Still Water Phases 5 and 6 Final Plats 2000 West Parkview Drive

#### **Still Water Subdivision Phase 5**

#### Still Water Subdivision Phase 6

# STILL WATER PHASE 6

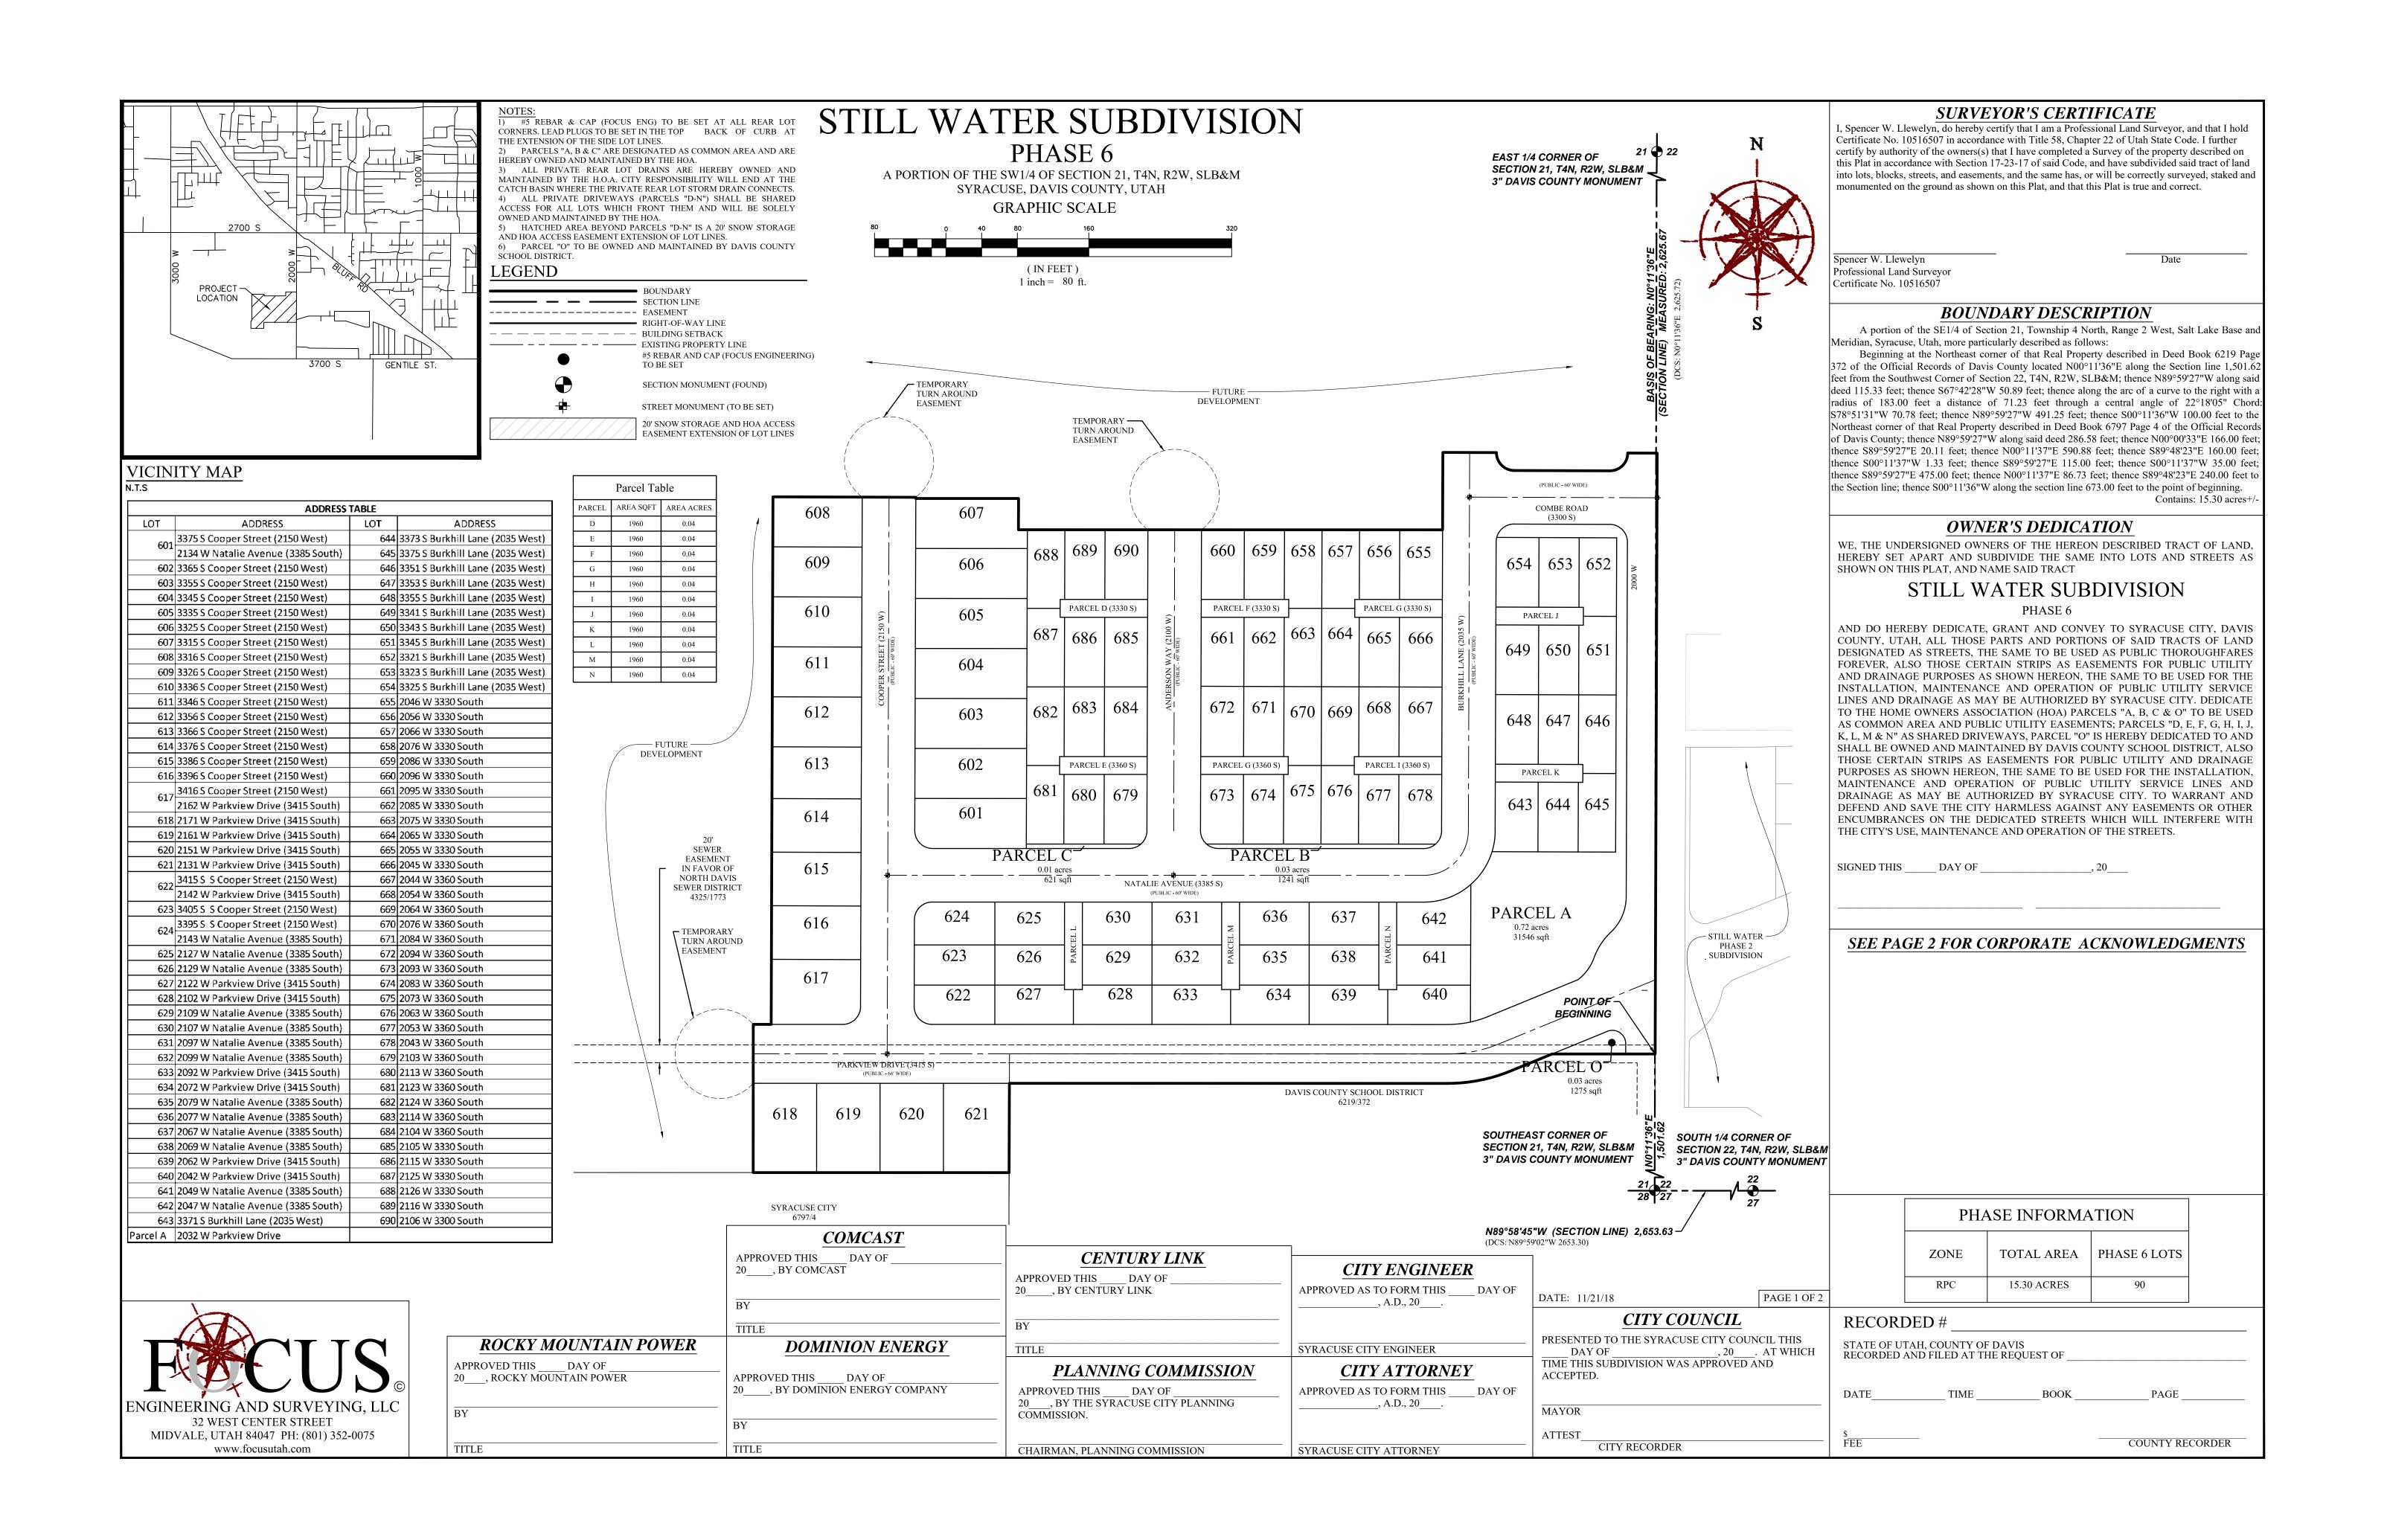
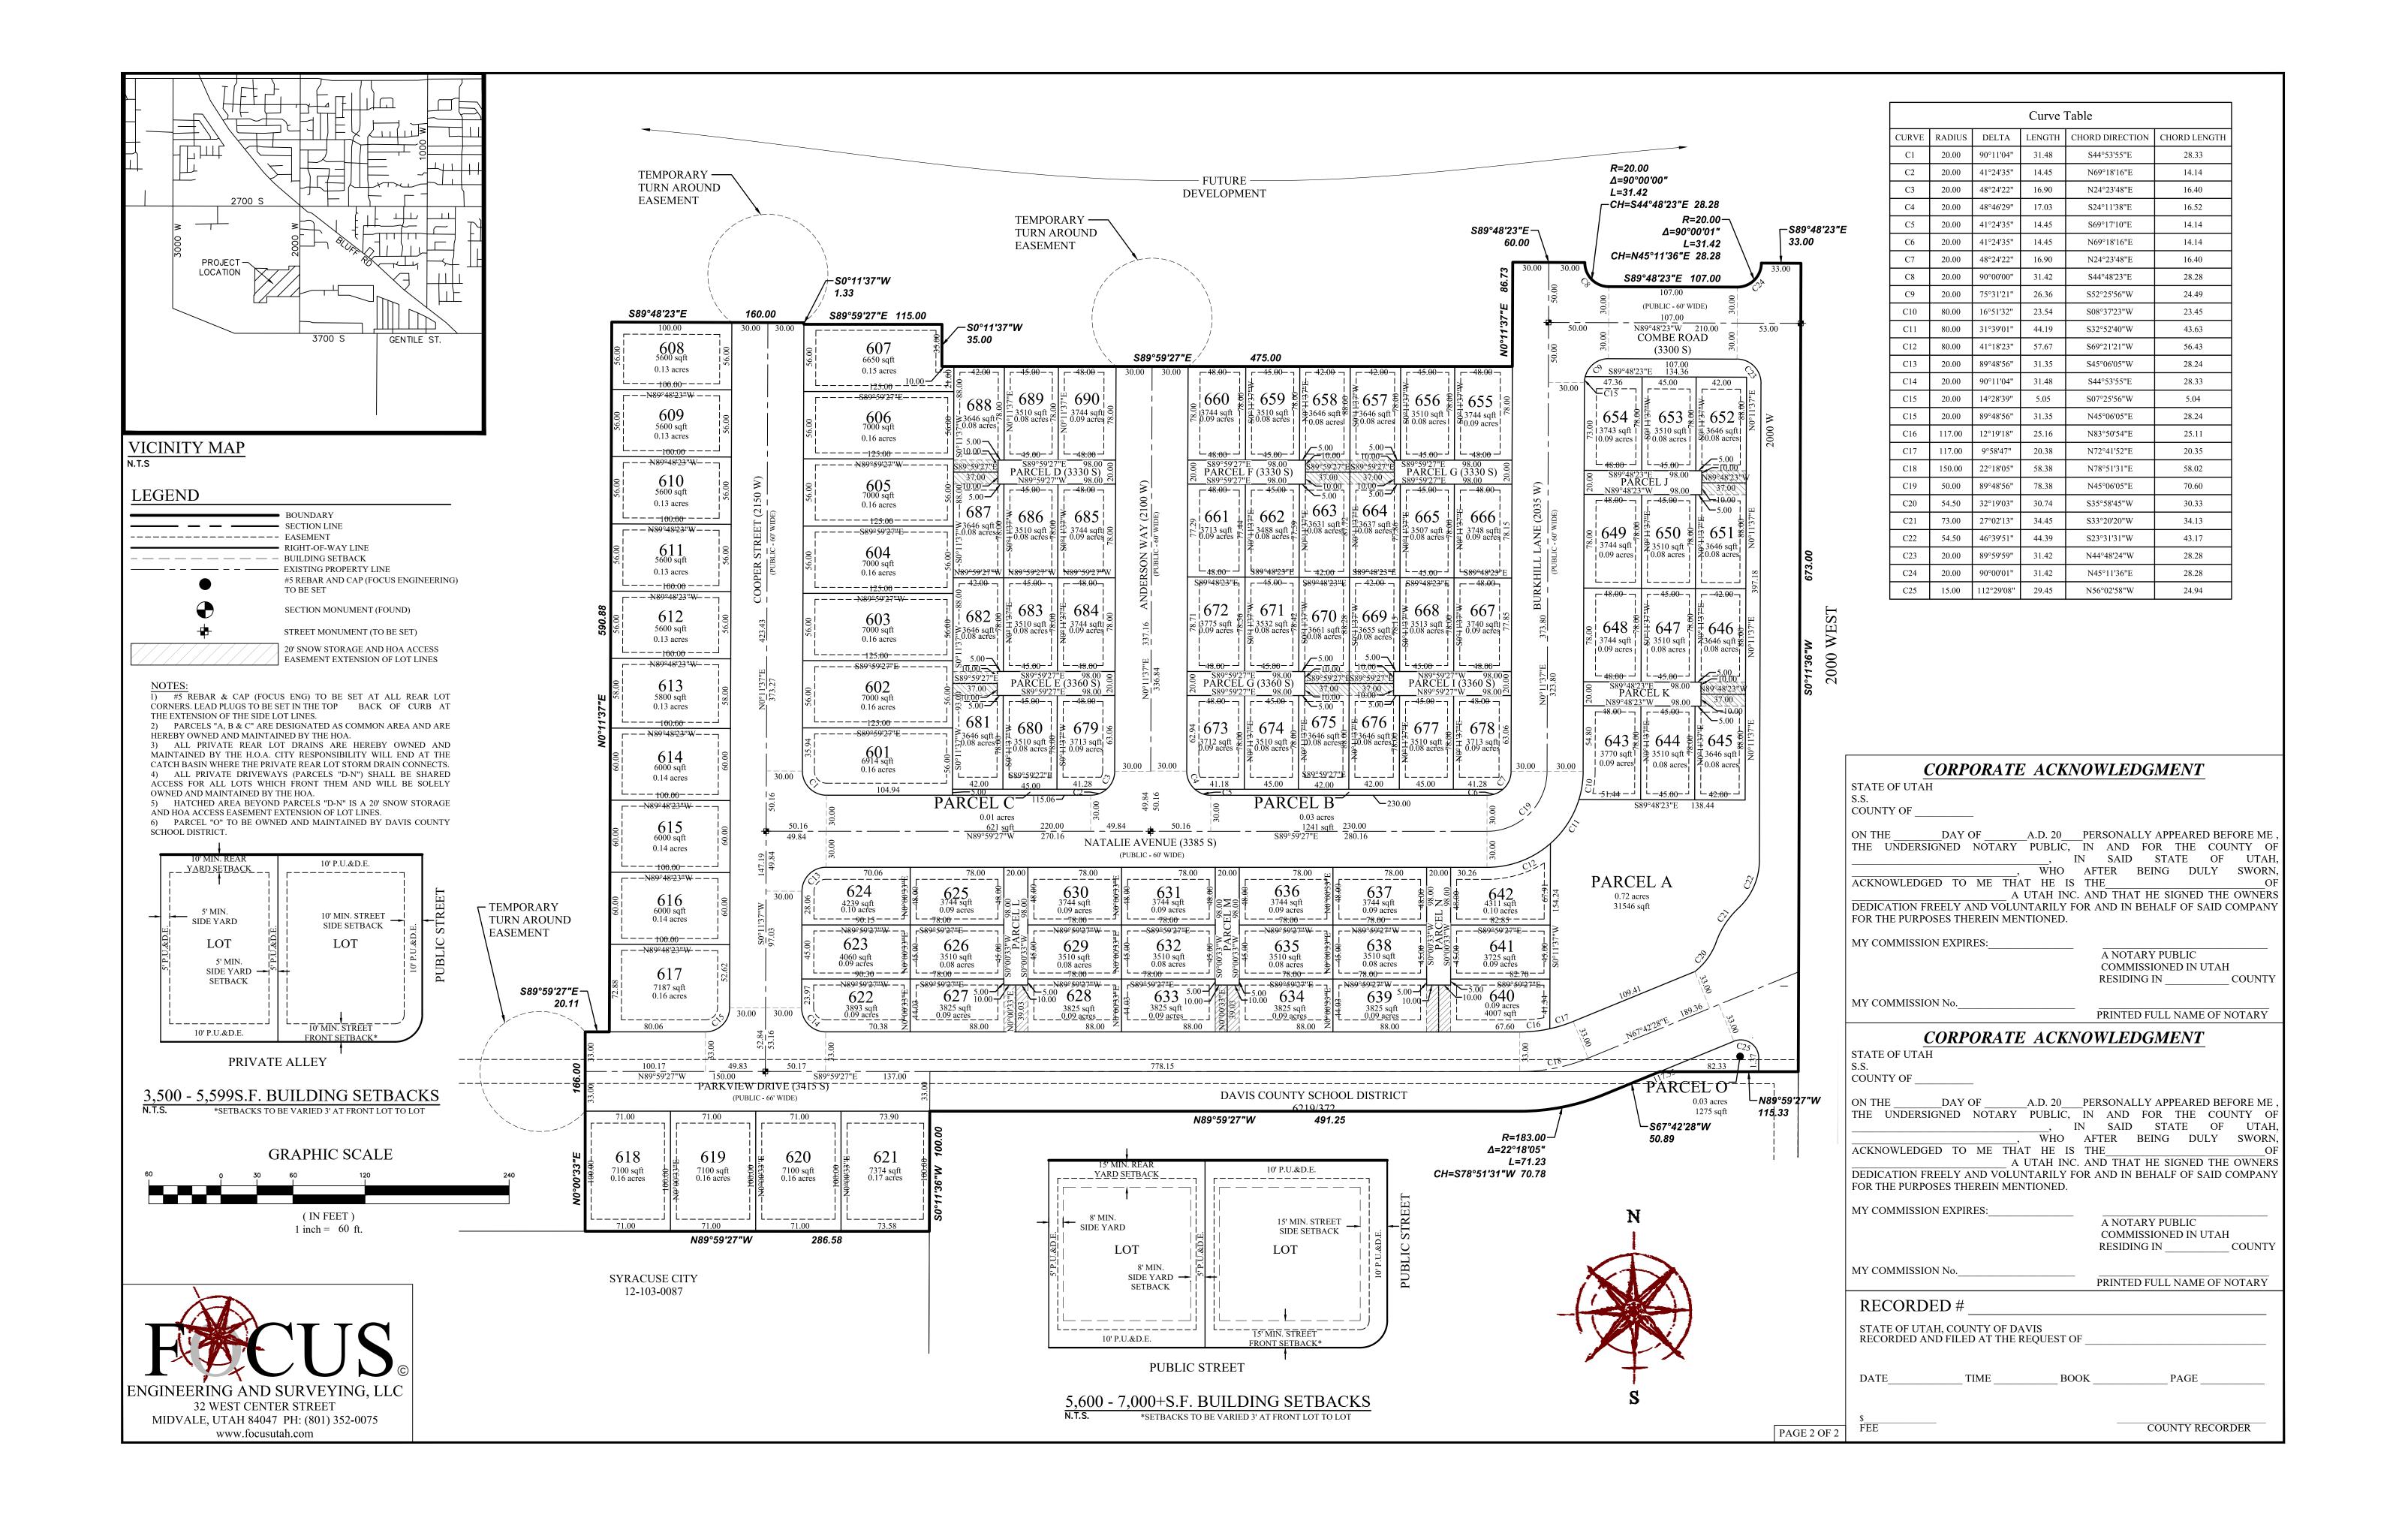
- The School District property will need to be dedicated to the City for Parkview Drive & 2000 West Street.
- 2. The owner's dedication and Note 6 conflict.
- 3. Dedicate a public utility easement over Parcel O.
- 4. Update the owner's dedication to reflect this phase.
- 5. There are two Parcel G's shown.

- 1. North Davis Sewer District shall be contacted for approvals for all connections to their main.
- 2. All valves shall be gate valves. Butterfly valves are not permitted.
- 3. Add a street light between Lots 633 and 634.
- 4. The street signage on Parkview Drive around the round about shall match what was installed with the other 3 legs.
- 5. Per the development agreement, the existing culinary and secondary waterlines shall be upsized to 10" lines from 3350 South to 3000 South Street with this phase.
- 6. All inverts in on sewer manholes shall be the same with 0.2' minimum drop through the manhole.
